**WASHINGTON METROPOLITAN AREA TRANSIT AUTHORITY
OFFICE OF BUS MAINTENANCE
ENGINEERING MODIFICATION INSTRUCTIONS - BUS**

New Flyer Xcelsior Compressed Natural Gas (CNG)
Haldex Air Dryer Retrofit
(2830-2993)

WMATA BUS ENGINEERING (BENG)
EMI No.: 22-AS-01-00
Page 1 of 18

**New Flyer Xcelsior Compressed Natural Gas (CNG)
Haldex Air Dryer Retrofit
SR1947; Fleet 55: (2830-2993)**

Figure 1: Graham White Air Dryer Removal

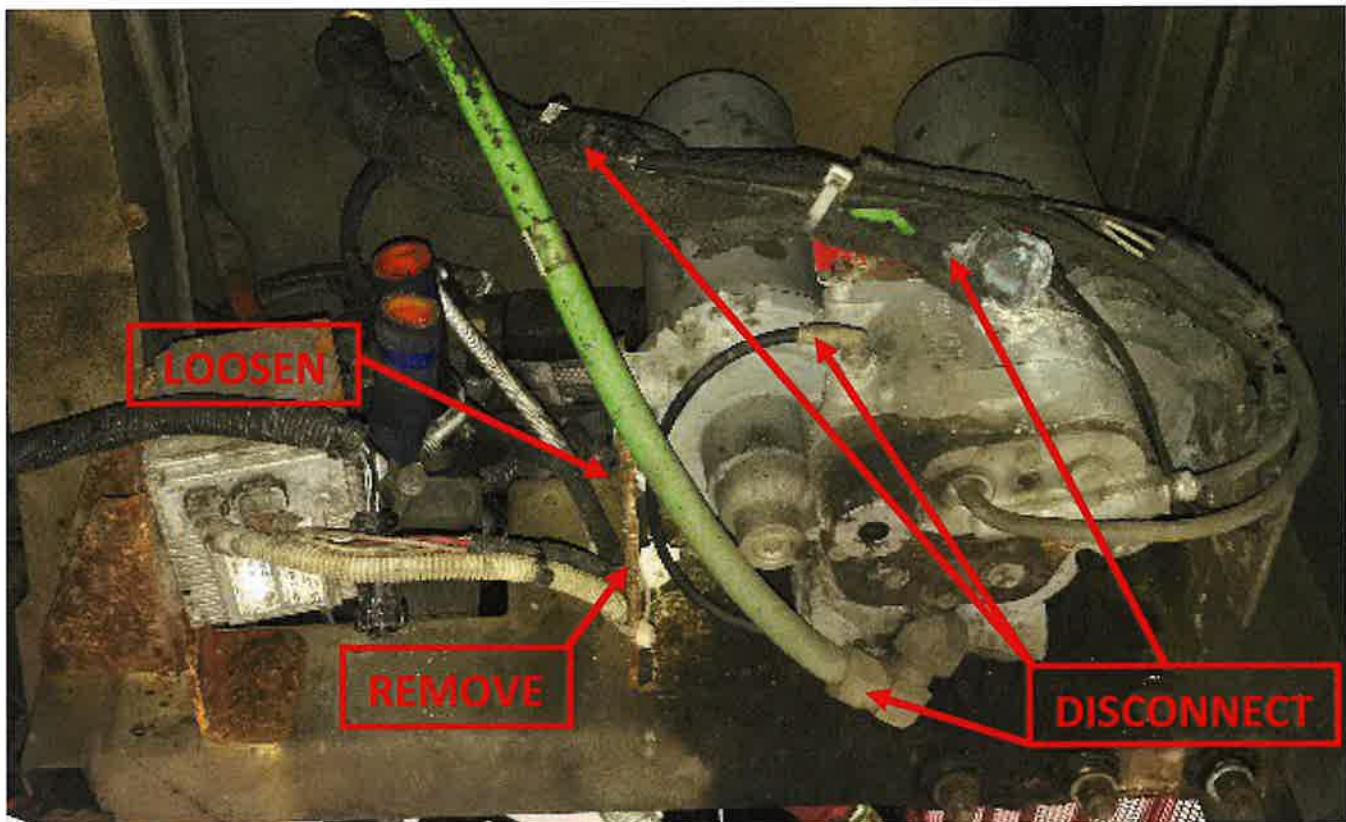
remove fasteners to prevent the air dryer assembly from falling. Lift up and forward to remove the air dryer assembly from the mounting bracket, see Figure 1.

Figure 3: Dual Consep Mounting Plate

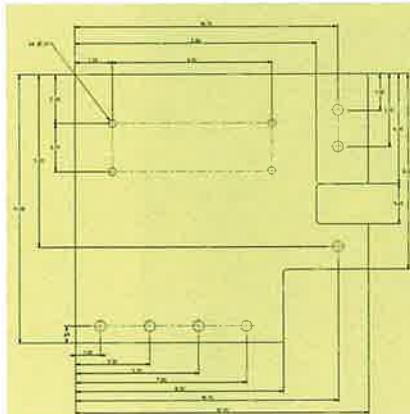
- 7.4.1 Use the Dual Consep Mounting Plate, Figure 3 and Purge Tank Template, Figure 4, to mark the mounting hole locations on the roadside vertical and lower horizontal frame members forward of the air dryer assembly and adjacent to the rear aft air spring. Position the Dual Consep Mounting Plate to overlap the vertical and lower horizontal frame members. Align the edges of the plate with the frame members sides and clamp in place, see Figure 5. Position the Purge Tanks Template's tabs in the plate slot and above the plate, see figure 6.

Figure 8: Dual Consep Mounting Plate & U-Bolts

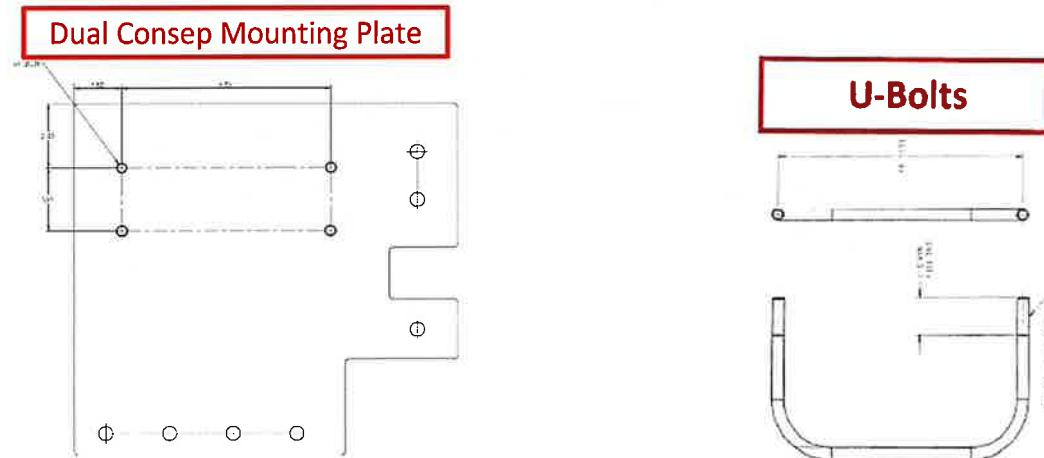
- 7.4.6 Install the purge tank using 3/8" – 16 x 1-1/4" bolts with never-seize applied and washer at each rivnut location. Tighten each bolt to 20-25 ft.lb.
- 7.4.7 Install the Dual Consep onto the Dual Consep Mounting Plate using two U-bolts. Tighten the U-bolt nuts to 6-11 ft.lbs in a cross pattern. See Figure 8.

Figure 14: Vansco Module 13 J4 Connector Location at Rear Rack Electrical Panel

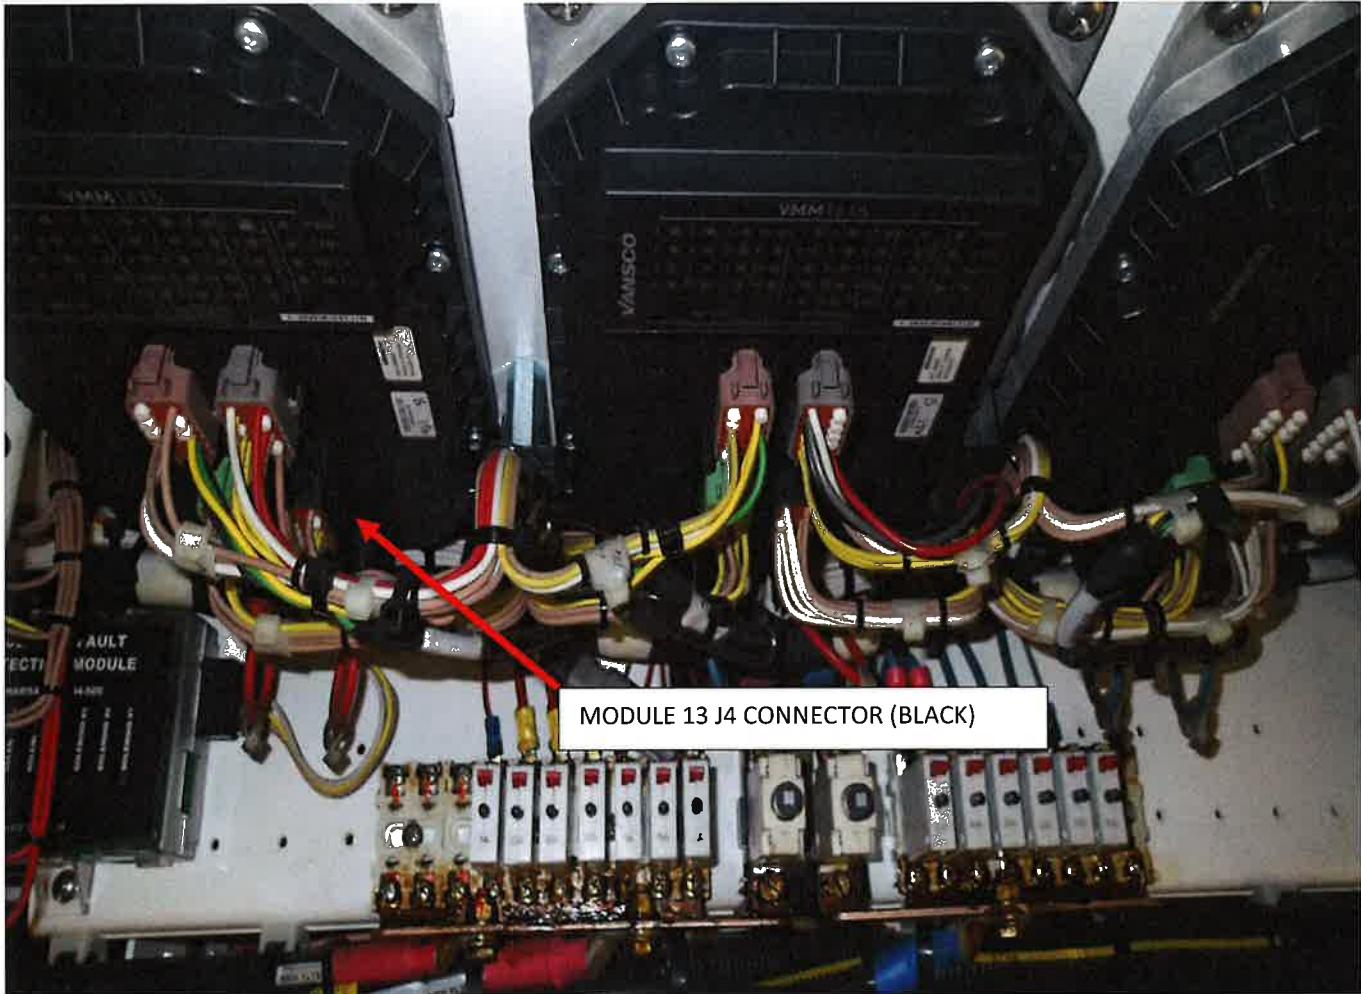
1. Working in the Rear Rack electrical panel, locate terminal strip **XRR10** See **Fig. 13**
2. Remove the nut from **post #2** and remove wire **60CC08C**.
3. Move Wire **60CC08C** to **Post #4** of the same terminal strip **XRR10** See **Fig.13**
4. Reinstall the nut on **Post #2**.
5. Cut a piece of **#16 TAN** wire approximately 3 feet long and install a **#10 ring terminal** on one end.
6. Secure the **Unmarked TAN** wire on **Post #4** together with wire **60CC08C** with a 10-32 brass nut.
7. Route the other end of the **Unmarked TAN** wire to Vansco Node 13 Connector J4 (black). See **Figure 14**
8. Install a **906-39-0055** terminal onto the **Unmarked TAN** wire and insert it into **position J4-8**.
9. Secure all wiring

Fig.1: Failed Flex Connector

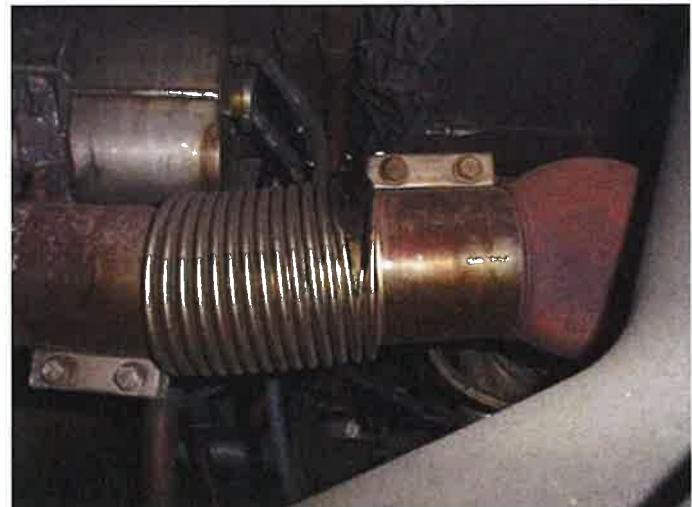
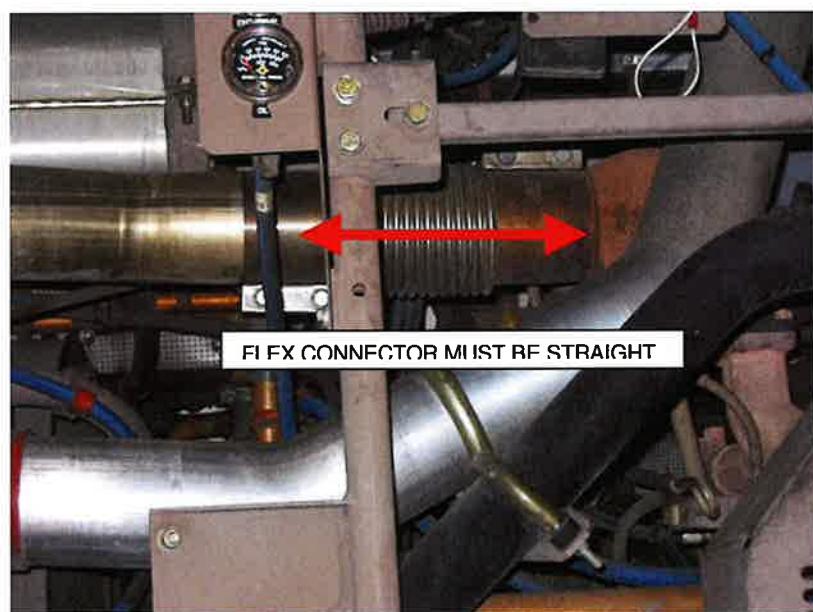
1. Turn the main battery disconnect switch to the "OFF" position.
2. Open the rear engine access door.
3. Remove belt guard.
4. Inspect exhaust tubes installation for proper alignment specification. Refer to Appendix A.
5. Inspect Vibrant flex connector P/N 089572 for visible crack or signs of failure. See Fig. 1 below for common flex connector failure.

7. Reinstall hybrid exhaust tube using new seal clamp 5" P/N 053791. Leave clamp loose enough to be able to manipulate pieces into proper position.
8. Line-up the exhaust tubes making sure that the centerlines of the exhaust elbow and hybrid exhaust tube are aligned. This will ensure that the new flex connector can be installed without twisting or stretching it beyond its' limits.
9. Install a new Vibrant Exhaust Bellow P/N 089572 using new seal clamp 4" P/N 089572. Leave clamp loose enough to be able to manipulate the flex connector into proper position.
☞ **NOTE: Make sure the flex connector is not stretched or compressed when attached to the exhaust pipes.**

Figure 1 Hinge Bolt Location

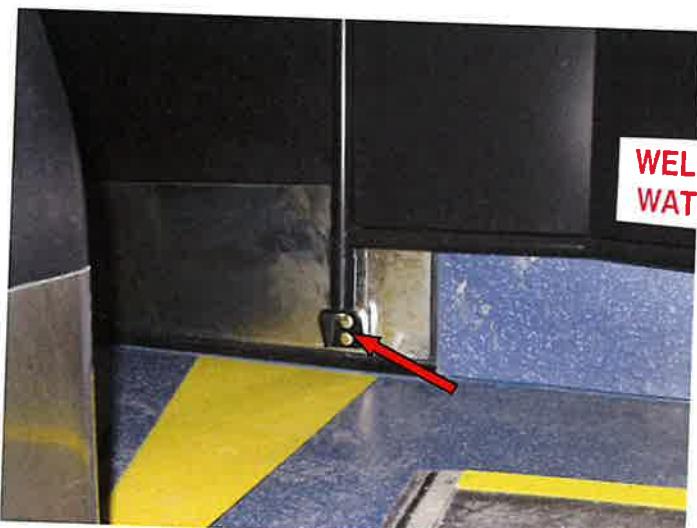
New Flyer has identified some instances of the driver's barrier door pivot hardware coming loose. Over time the lower hinge may loosen, eventually allowing the barrier door to drop. In order to prevent the lower barrier hinge bolt from coming loose the bolt must be removed and installed with Loctite 243 or approved equivalent Vibra –Tite 121 Medium Strength Removable Thread locker, available in the Fastenal vending machines

SUBJECT: AGM ODYSSEY 31-PC2150 BATTERY
NEW VERSION & BATTERY CLEANING DATE: October 4, 2016

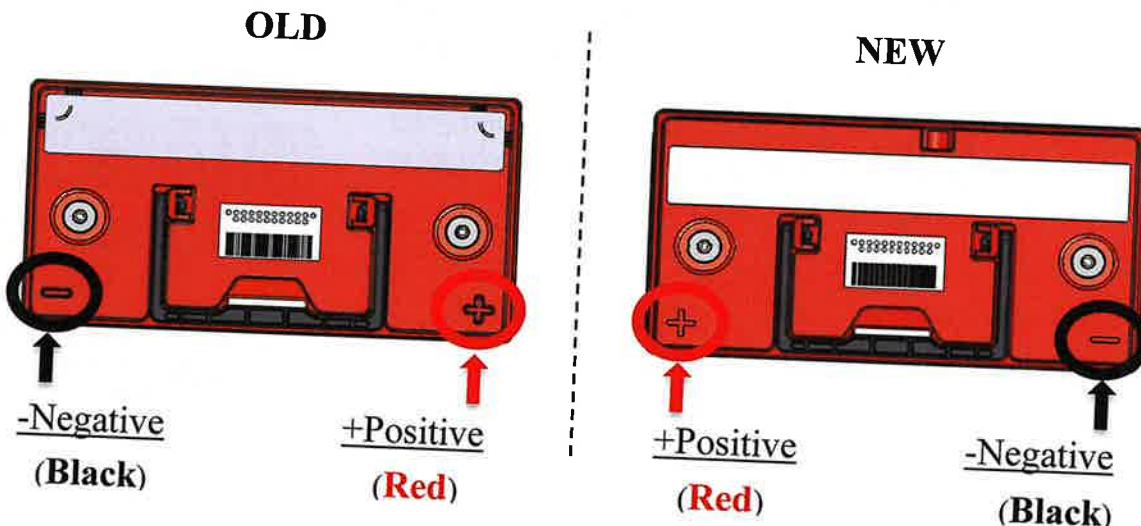
- 1. Polarity Change** – The terminal orientation has been changed to follow BCI specifications for a G31 battery. The new design has the positive terminal on the left and the negative terminal on the right.

The most important change affecting BMNT is the Polarity Change. When replacing previously installed 31-2150's with the new design, pay careful attention to the terminal polarity. Only positive (+) and negative (-) terminal reference should be used. Do not reference any other features of the battery such as handles or front decal. Major damage to electrical system may occur as a result of reverse (backwards) installation.

Figure 3 Aeroquip Transmission Fluid Lines

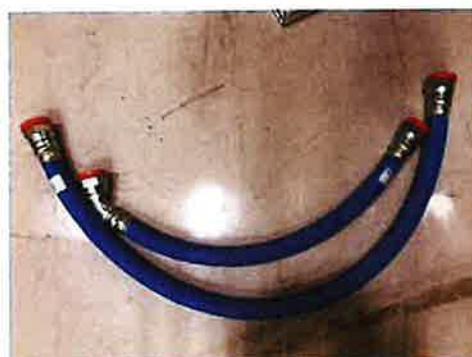
The transmission fluid lines that run to/from the transmission to the transmission cooler are deteriorating (see Figure 1) due to the increased temperatures in the engine compartment of CNG buses. The current hoses are made of a black Manulli material (see Figure 2). Upgraded hoses have been identified and placed in stock. The upgraded hoses are made of a blue Aeroquip material (see Figure 3). The stock number for these new hoses are WMATA # 906-70-0101 (New Flyer # 6366943) and 906-70-0121 (New Flyer # 6366944). A campaign to replace the Manulli lines with the upgraded Aeroquip lines has been generated under Job Plan 8091. Any deteriorated lines should be replaced as soon as practicable. Replacement instructions can be found in the Attachments section of the campaign work orders
